CITY PLAN COMMISSION

FILE NUMBER: M245-001(TB) DATE FILED: October 4, 2024

REQUEST: An application for approval of a site plan that does not comply

Elevation Plan- Reference only

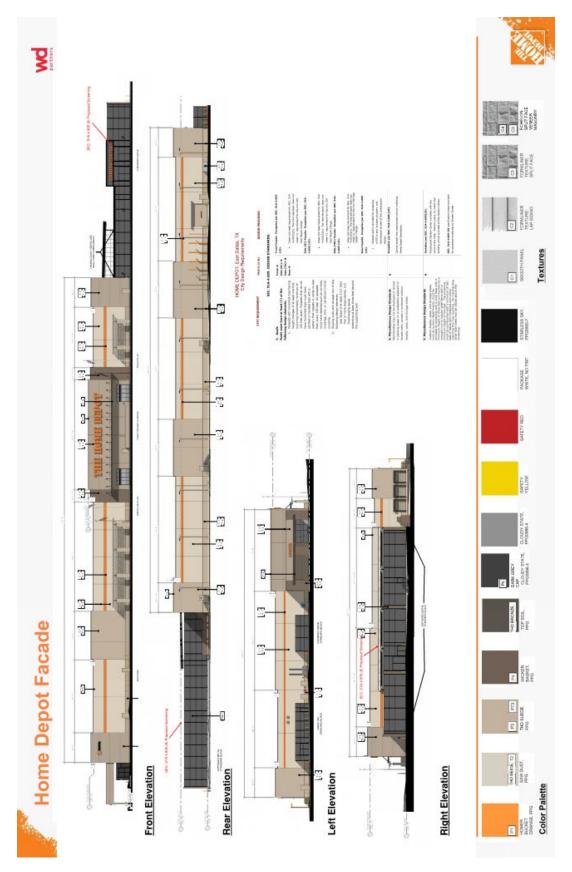
All parapets have height changes of at least one foot occurring horizontally at less than every 100 feet. Neither of the required roof design elements along the rear facade of the building.

- Raised parapets would require a change of tilt panel color and texture, as well as removal of that portion of the horizontal branding stripe.
- The applicant is concerned about the competitive challenges from the loss of branding caused by the removal of the horizontal stripe. They have attempted this design on a previous store, and it was found to negatively impact customer recognition and sales.
- Parapet and/or overhanging eaves on the rear facade would interfere with forklift operations.

Staff recommends approval of the proposed site plan allowing the noted exceptions and variations from the design standards for large retail uses and finds that the standards for approval have been met. Given the surrounding uses and the site's location on a regional commercial corridor, it is not anticipated that the exceptions and deviations will adversely affect surrounding properties. Strict compliance with the design standards inhibits standard operations and eliminates recognizable brand features. Staff notes that the majority of design standards for large retail uses will be incorporated into the applicant's future redevelopment of the property, and the requested exceptions and variations comply with the spirit and intent of the required design standards. Approval of the site plan reflecting the requested exceptions and variations will allow a currently vacant property to be redeveloped, thus contributing to the revitalization of the area.

Elevation Plan (Enlarged)- Reference Only

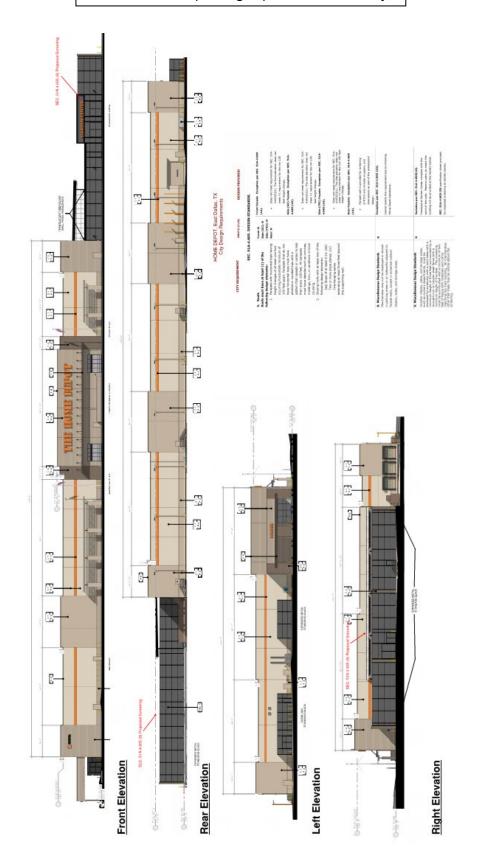
- Provide 20-foot-tall masonry columns to match the building at north side of the garden center fence in lieu of the solid base wall.
- No masonry columns are proposed along the front entrance or rear facade of the garden center.
- Provide expanded metal mesh (0-12') and architectural mesh (12'- 20') mounted to steel fence posts in lieu of wrought iron or tubular steel.
- No solid screen wall to be provided.

Proposed Site Plan

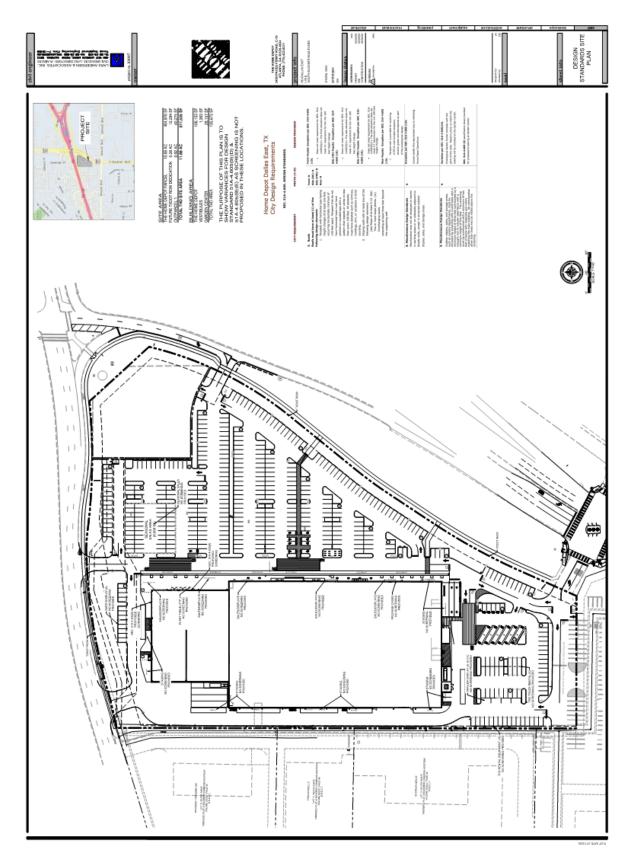
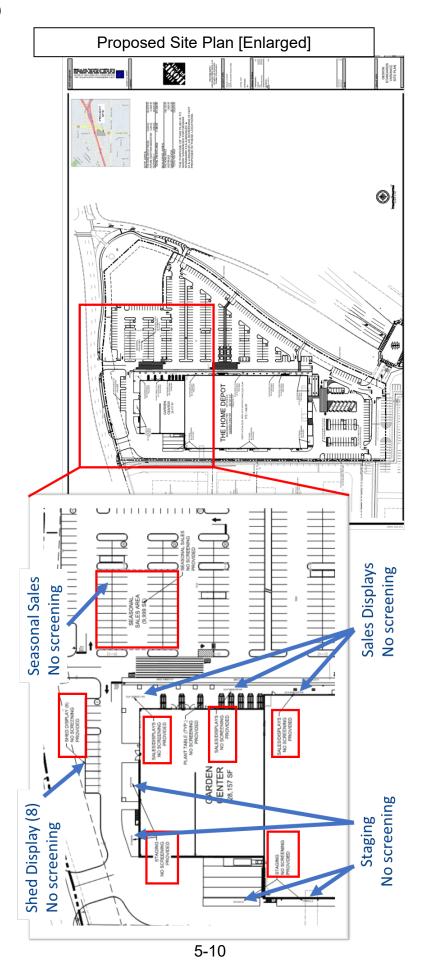
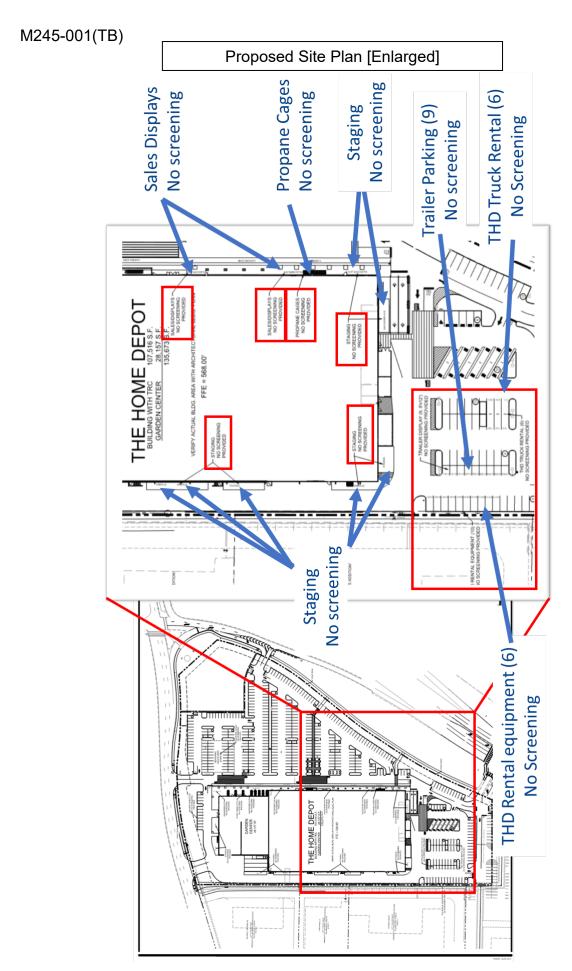
- Staging and outdoor display along the facade walls.
- Seasonal sales within the parking lot.
